# Westinghouse

TESTING REACTOR

Subject: License No. TR-2  
Docket 50-22

Modification  
to  
Venting System  
for  
WTR Process Water Head and Surge Tanks

SURGE TANK & HEAD TANK AIR PURGE SYSTEM

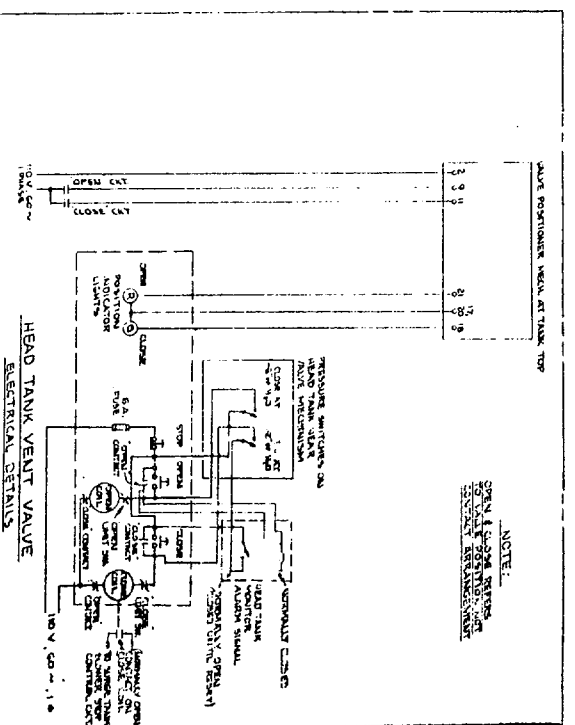
The proposed modification of the system shown on Drawing No. 783-D-659, limits the discharge of the radioactivity to permissible concentrations by adding a valve to the head tank vent line and revising the controls of the air supply blower.

The valve is a butterfly valve with an offset shaft which permits continuous contact between a rubber seat and the valve disc

edge when the valve is closed. Valves of the same design have been used in the WTR vapor container ventilation system and have proven to be leak tight and satisfactory. The valve is opened and closed by an electrical operator mounted on the valve body.

A high level (trip) signal initiated by an activity level of  $2.3 \times 10^{-1} \mu\text{c/ml}^*$  at the head tank monitor will cause the vent valve to close, the supply fan to shut down, and the supply line valve to close. The head tank monitor will remain in operation but will only sample air from the vent past the vent valve. A pressure switch will be installed on the head tank which opens the vent valve if the pressure in the tank drops below atmosphere. The switch will be set to open the valve at minus 6-inches of water and close the valve at minus 2-inches of water. All air flow under these conditions would be into the system. Manual reset of the control system is required after the head tank monitor causes the valve to close.

An alarm point for the head tank monitor will be set at a lower value than the trip signal to permit evaluation of the conditions before the vent valve is closed. If the activity reaches the level required to close the valve, the reactor power will be reduced manually to approximately 5 MW and a survey made of the radiation level in the plant. If a fission break has occurred, it will be easily detectable on the plant area monitors. If such evidence is not found the vent valve circuit will be reset and normal operation resumed.
